**SOUTH GROUNDWATER CONTAMINATION
PLUME REMOVAL ACTION EE/CA/ ADDENDUM**

**DOE-2259-91
DOE-FSO/USEPA
3
LETTER**

ADDENDUM TO SOUTH GROUNDWATER CONTAMINATION PLUME REMOVAL ACTION EE/CA
September 14, 1991

FIGURE 1
New location of Recovery
Well Field

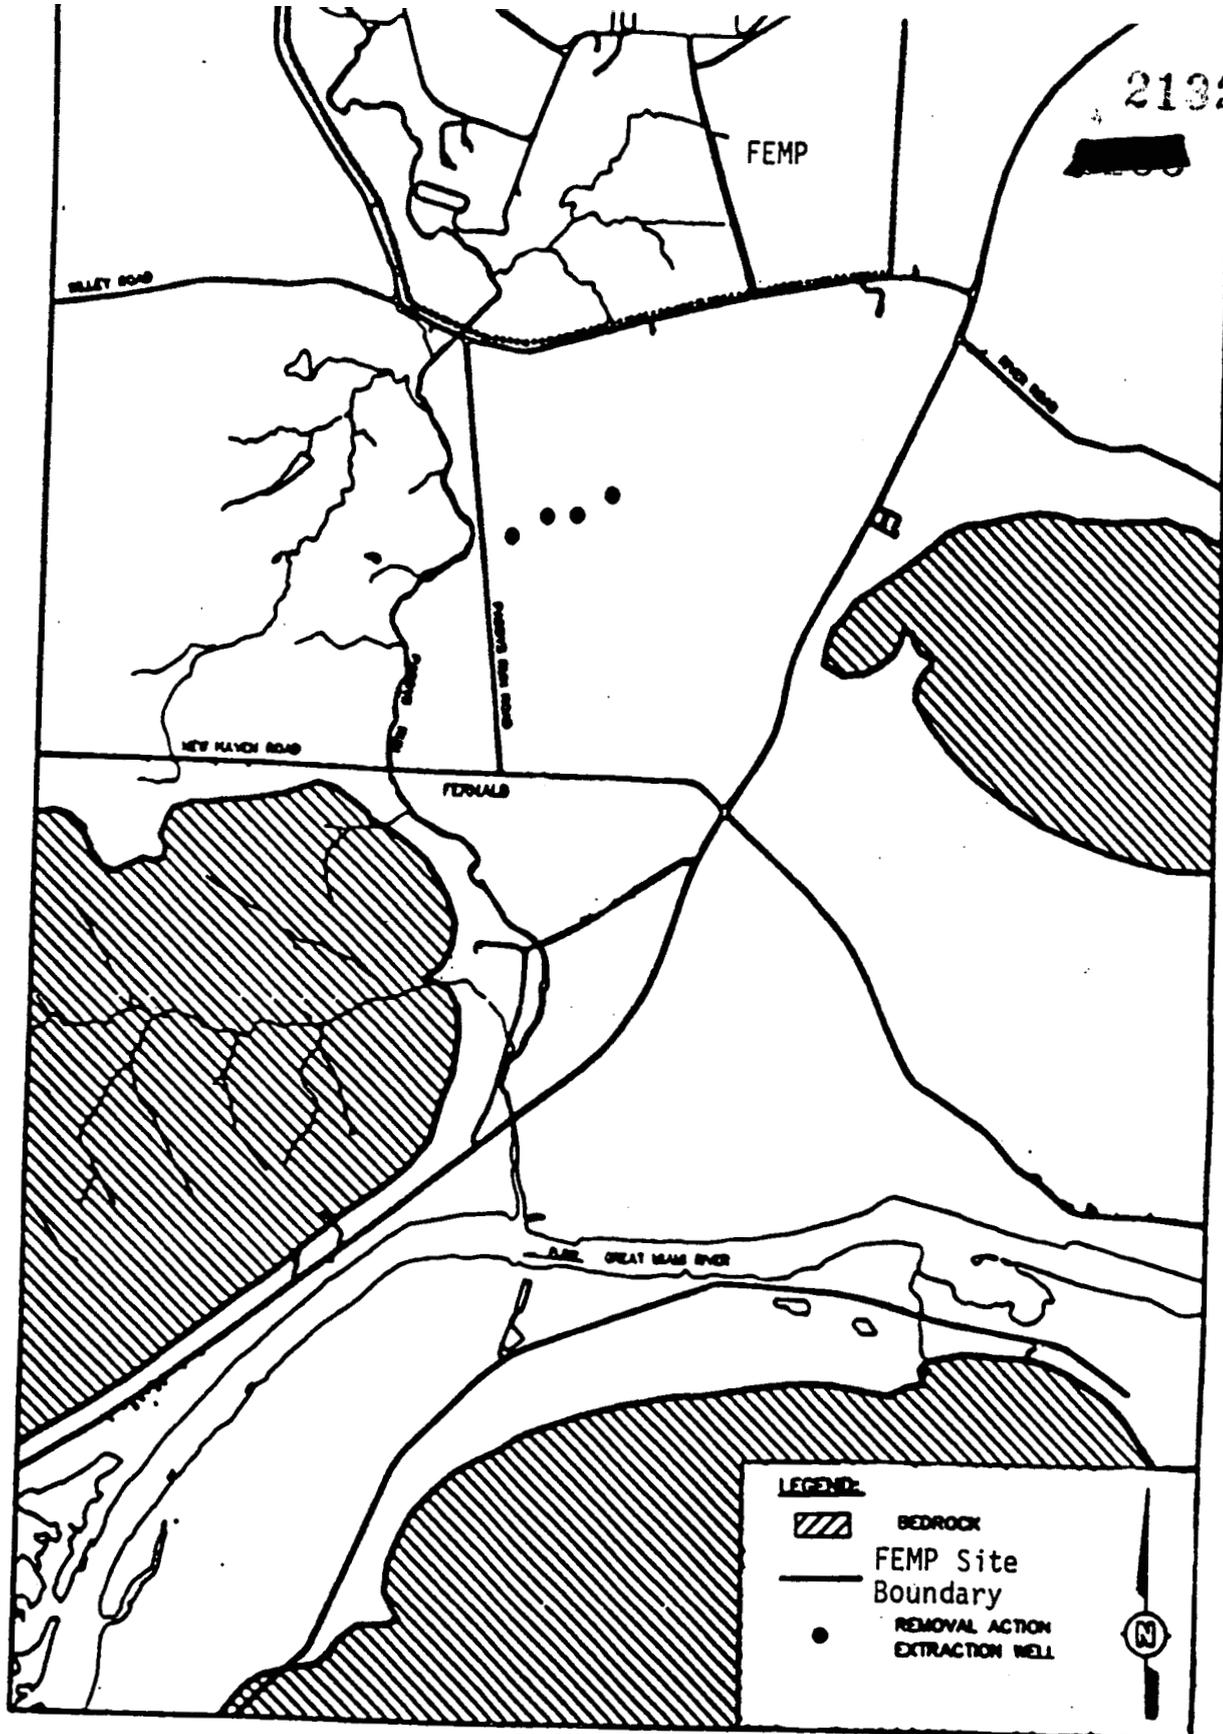
As a result of these conditions, it has been deemed necessary to relocate the Part 2 well field to an area north of the PRRS. Modeling efforts have been performed to determine a location where pumping of the recovery well field will not significantly affect the PRRS plume and will not draw PRRS contaminants into the recovery well field. Figure 1 depicts the new location of the South Plume Removal Action Part 2 well field.

- Page 4-5:** Paragraph 4 is modified to: Three to five recovery wells are tentatively planned for installation north of the Albright & Wilson Americas (AWA) Plant. The recovery wells are shown conceptually in Figure 1 of this Addendum.

FIGURE 2 PROPOSED SAMPLING LOCATIONS FOR PART 5

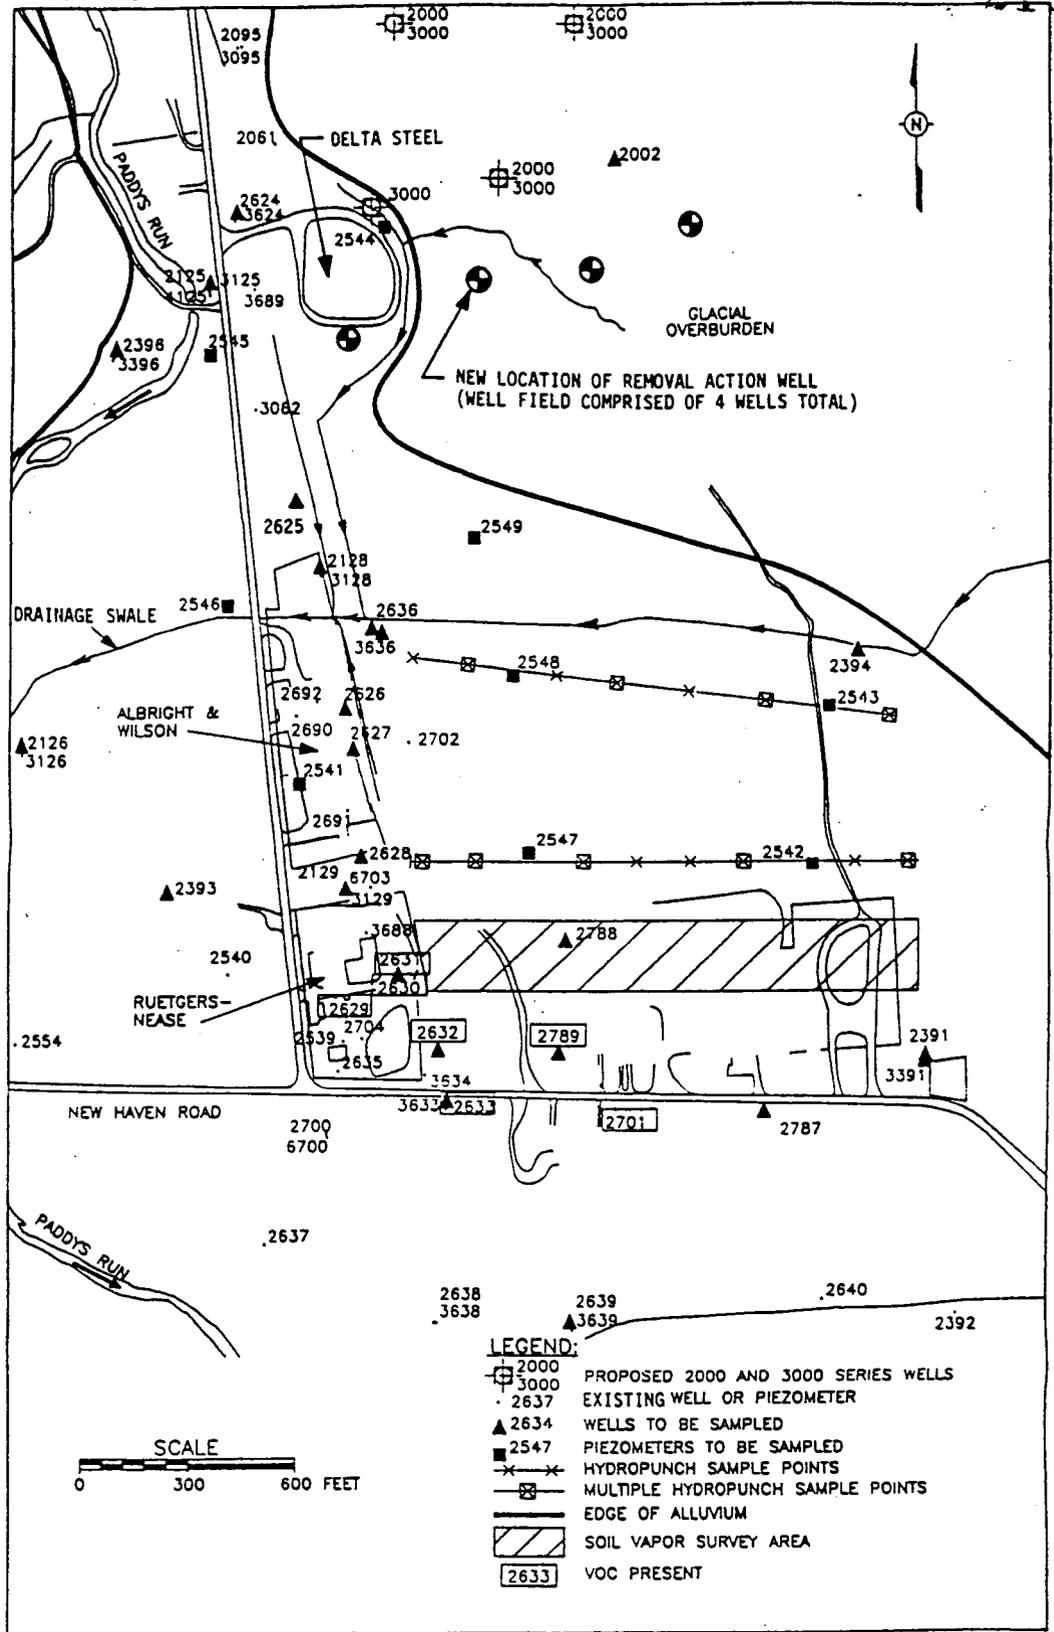
In addition, the relocated well field is upgradient of an area of known 30 ug/l uranium contamination. The computer model for the South Plume predicts that other areas could also exist where the level of uranium concentration is above 30 ug/l. Therefore, an additional investigation will be performed under a new Part 5 of the South Plume Removal Action. The Part 5 investigation will include hydropunching and soil vapor survey of the area south of the well field to New Haven Road (Figure 2). The investigation will identify the location of the 30 ug/l uranium isopleth. Because the EPA has recently issued a proposed revised limit of 20 ug/l for uranium in drinking water, the investigation will also identify the location of the 20 ug/l isopleth. The information obtained will be used to allow the FEMP to limit access to this water until final remediation of this area is implemented.
